Docket Item #8-A&B
DEVELOPMENT SPECIAL USE PERMIT#2004-0025(A)
SPECIAL USE PERMIT (TMP) #2004-0097(B)
FOXCHASE SHOPPING CENTER

Planning Commission Meeting
February1, 2005

DSUP #2004-0025: Consideration of a request for a development special use permit, with site plan, for redevelopment of a retail use greater than 20,000 square feet, parking reduction and freestanding signs.

LOCATION: 4513-4657 Duke Street
Foxchase Shopping Center

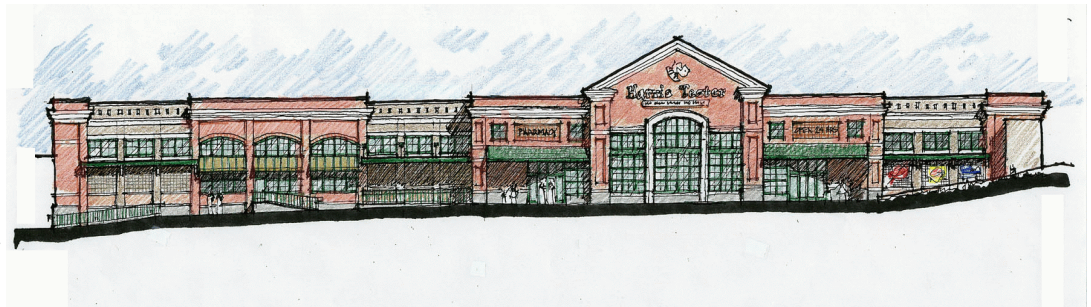
Originally, the applicant proposed a "standard" suburban grocery store with an entrance and blank walls for the 60%-70% of the remaining length of the grocery store facade. The initial design did not make any attempt to accommodate pedestrians or to reduce the perceived scale or length of the building and was inconsistent with the smaller retail bays of the remainder of the retail center.

To reduce the perceived scale and length, the City has worked with the applicant to create seven smaller bays, applying higher quality materials, murals, display windows and windows at the pedestrian level to establish a more comfortable "pedestrian scale" environment along the sidewalk frontage. The side of the structure will have windows and treatment to reduce the perceived scale from the street and parking areas. With the architectural improvements, the proposed grocery building is also more consistent in character with the proposed new facade of the remaining shopping center. With these considerable changes and some additional refinements staff is recommending approval.
